# UNITED STATES PATENT AND TRADEMARK OFFICE

APPLICATION NO.	FILING DATE	FIRST NAMED INVENTOR	ATTORNEY DOCKET NO.	CONFIRMATION NO.
10/689,710	10/22/2003	Hiroyuki Taguchi	SHO-0018	4644
23353	7590	08/24/2004	EXAMINER	
RADER FISHMAN & GRAUER PLLC LION BUILDING 1233 20TH STREET N.W., SUITE 501 WASHINGTON, DC 20036			TSUKERMAN, LARISA Z	
			ART UNIT	PAPER NUMBER
			2833

## Office Action Summary

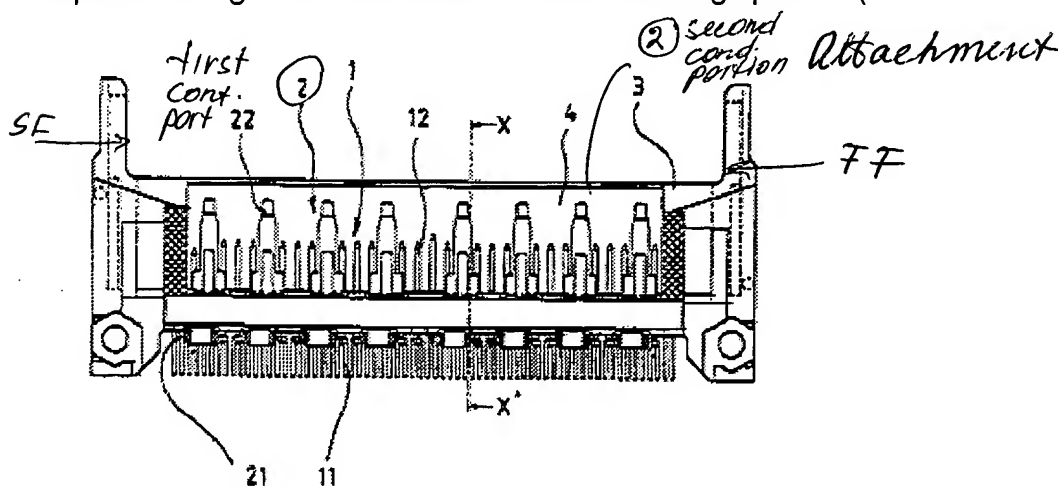
**In regard to claim 1**, Hirata **discloses a connector** (not marked) for connecting a **grounded board 6**, the connector having a **card** (not shown) and a **housing 3** for housing the card, the **housing 3** comprising:

a non-conductive housing main **body** (not marked) having a housing **space 4** for housing the card;

**contact 1** for connecting the card housed in housing space 4, the contact 1 being disposed in the housing main body (see Fig.3); and

a **first conductor portion 2** for connecting the card housed in **the housing space 4**, the first conductor portion 2 being disposed in the housing main body and insulated from the contact (see Col. 3, lines 40-50 and Fig. 3), and

**In regard to claim 4**, Hirata discloses a second conductor portion 2 disposed along a **second side face SF** of the housing space 4; wherein the first conductor portion 2 is disposed along a first side face FF of the housing space 4 (see Attachment).
